COMMISSION ACTION FORM

REQUEST: Major Site Development Plan/Preliminary Plat Revision for a Commercial Development at Stange Road and Northridge Parkway (SDP-09-18).

LOCATION: Southeast corner of Stange Road and Northridge Parkway

LAYOUT PLAN

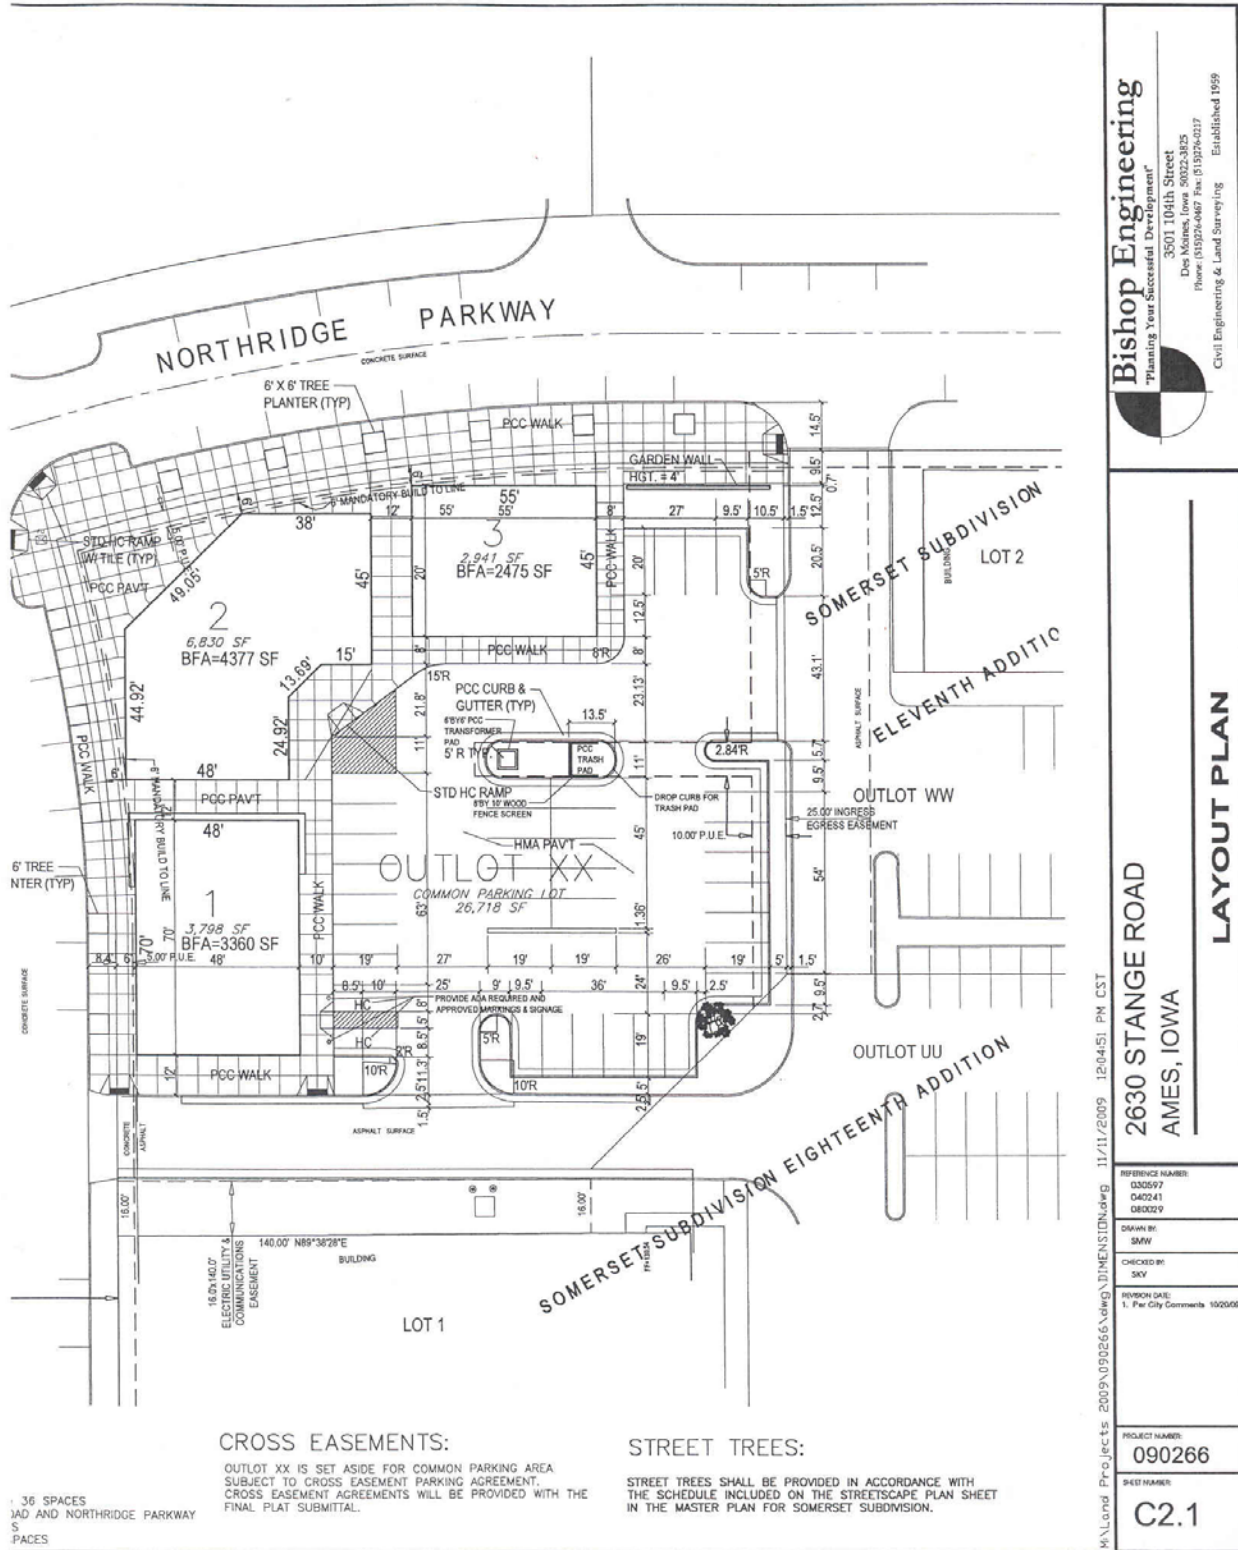
The proposed parking lot does not require interior landscaping. However, the landscaping plan shows an interior island with a tree and several bushes. While the bushes serve as screening for the utility cabinet, all add an element of landscaping where none is required by code. The perimeter parking lot, however, does not meet the requirements of Section 29.403(b) in that there should be a low screen of shrubs planted four feet apart along the south and east traffic islands. However, the lack of shrubs is compensated by the 7 ornamental crabs in those islands where, by code, only 3 are required. In addition, the southeast corner of the lot has an extensive planting scheme with a bed for annuals. While the specific spacing requirements are not met, staff asks the Commission to consider that the intent of the ordinance is met and to use the discretion granted by Section 29.403(g) and recommend to the City Council to accept the landscaping plan as submitted.

Section 29.408(3) Garbage Collection Areas: The proposed location of the dumpster within the parking lot is acceptable but needs to be screened to the F2 standard (6 feet high and 100 percent sight obscuring). While the location of the dumpster is shown, there is no indication of its height, materials, or whether there is a gate. Staff conditions its recommendation for approval on the applicant submitting this information that the F2 requirement will be met. There is also a contradiction in the materials on which the dumpster is placed. Sheet C2.1 identifies the trash pad as PCC (Portland Cement Concrete) while Sheet C5.1 identifies it as river rock mulch. PCC is the preferred material for this location and will condition approval on the applicant providing clarification.

Table 29.1207(7)-8 Village Floating Zone Regulations for Commercial/Shop Front: The build-to line of six feet for the commercial lots is met. Because of the curve of both Stange Road and Northridge Parkway, the building placement is a challenge to meet the requirements of the build-to line and the requirement that a “traditional ‘Main Street’ effect” be maintained. The approach that is taken is similar to that taken on the west side of the curved portion of Stange Road one block north.

In the area on the northeast corner along Northridge Parkway where there is no building, a four-foot garden wall is located. This is consistent with, and required by, the code.

The parking for this, as well as within the block and within the entire Village commercial area, is satisfied by a combination of on-street parking adjacent to and within 300 feet of the commercial area and by off-street parking lots. The parking calculation is based on one space for every 250 square feet of gross floor area (regardless of use). The parking requirements for this commercial space can be accommodated by all the existing parking within the block and on-street. The additional 37 spaces provided by the proposed off-street parking lot provide parking in excess of what is required.

- a. Submittal of information that the dumpster screening is gated, is six-feet in height, and is of a material that is 100 percent sight obscuring.
 - b. Submittal of the COSESCO paperwork prior to excavation.

- c. Correction of the plan to indicate that the proposed dumpster location will be PCC.
2. The Planning and Zoning Commission can recommend that the City Council approve the Major Site Development Plan and Preliminary Plat, with modifications.
